## City of Sugar Hill Planning Staff Report RZ 21-011

SUBJECT: Rezoning RZ 21-011, single-family detached homes

5060, 5376, & 5404 Sycamore Road

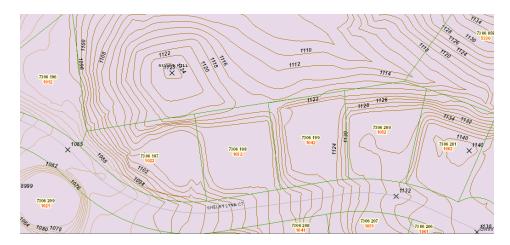
*Concern:* Neighbors have expressed concern that we would clear the entire property and remove large trees.

Response: The proposed community will strive to maintain as many of the trees as possible. The proposed community will maintain a landscape buffer of 20' adjacent to all neighboring residential communities. The community will have +/- 1 acres of buffer on the north and south of the property. The development will maintain +/- 4.25 acres of natural stream buffer and land to the southwest.

A large portion of the site had previously been cleared sometime between 2005 and 2006, as shown in the aerial map of the property. Because the site was cleared, there is not much large and old growth on the site. Our intent would be to save as much as possible though the landscape buffers and natural vegetative areas.
